Subject: Adjustment of the water ballast actuation inside the fuselage

Serial number applicability: All ASW 27

Fig. 1

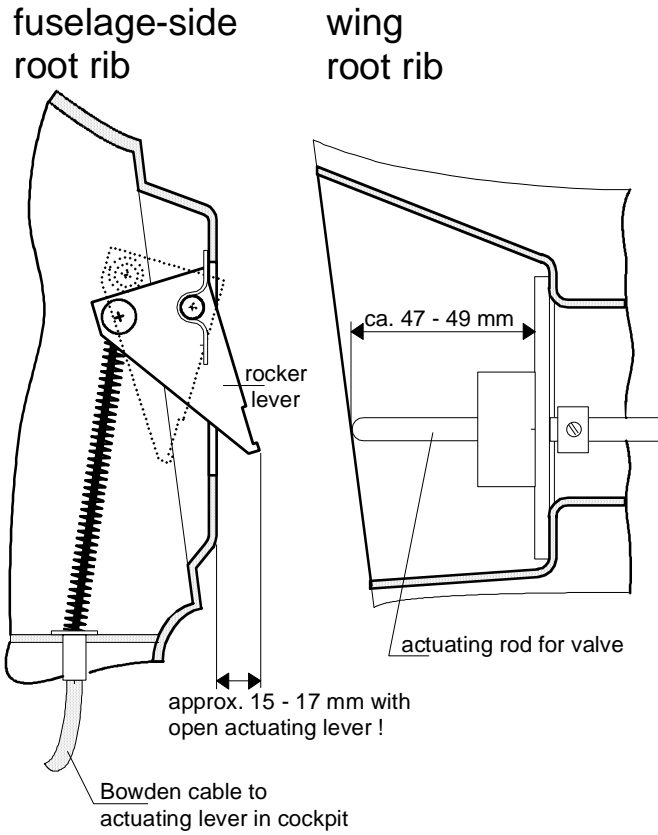
Action: Version 1:
As shown in Fig. 1, the correct adjustment of the valve actuation can be checked easily. The adjustment of the actuation system is done by turning in or out the adjusting screw at the front Bowden cable counter bearing (see Fig. 2). If the adjustment at the threaded bolt is not sufficient, the Bowden cable itself can be adjusted in length at the screw clamp (see Fig. 2.) Note that the cable is soft soldered into that clamp!

Version 2:
As shown in Fig. 1, the correct adjustment of the valve actuation can be checked easily. The adjustment of the actuation system is done at the rocker switch by turning in or out the lock nut at the threaded connector of the Bowden cable (see Fig. 3).
